SUBJECT: ADDENDUM #2 – Bid #21-08 Rosewood Arts Center Renovation

ADDENDUM #2 – Bid #21-08 Rosewood Arts Center Renovation

- 2. Phase 0 – Drawing 0.AS101 ARCHITECTURAL SITE DEMOLITION PLAN (*Sheet Not Re-Issued*)
 - a. ADDED sheet notes 16 to align tree demolition with scope of work noted in civil drawings.

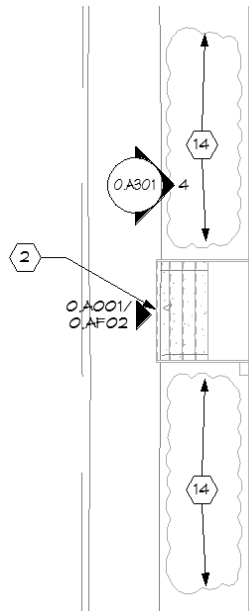
- b. MODIFY sheet notes related to landscape edits

3. Phase 0 - Drawing 0.AS102 ARCHITECTURAL SITE NEW WORK (*Sheet Not Re-Issued*)

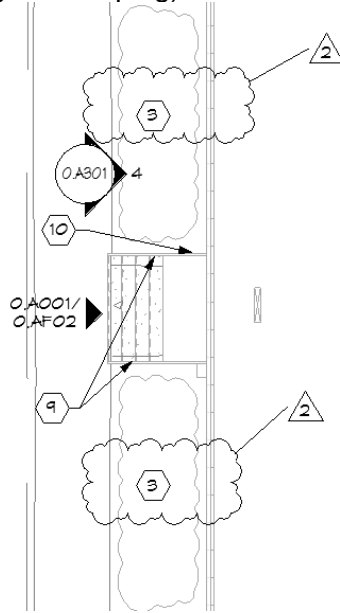
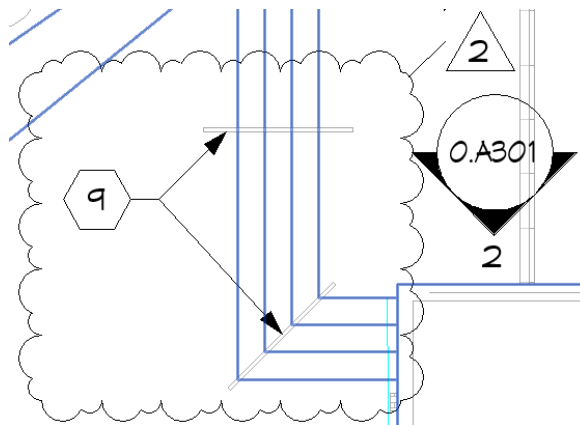
- a. MODIFY sheet notes near western door 136 from #7 to #3 to align with scope of work on 0.AS101 (removal of existing landscaping).

- b. ADD note to clean and repaint all existing metal handrails at current entrance
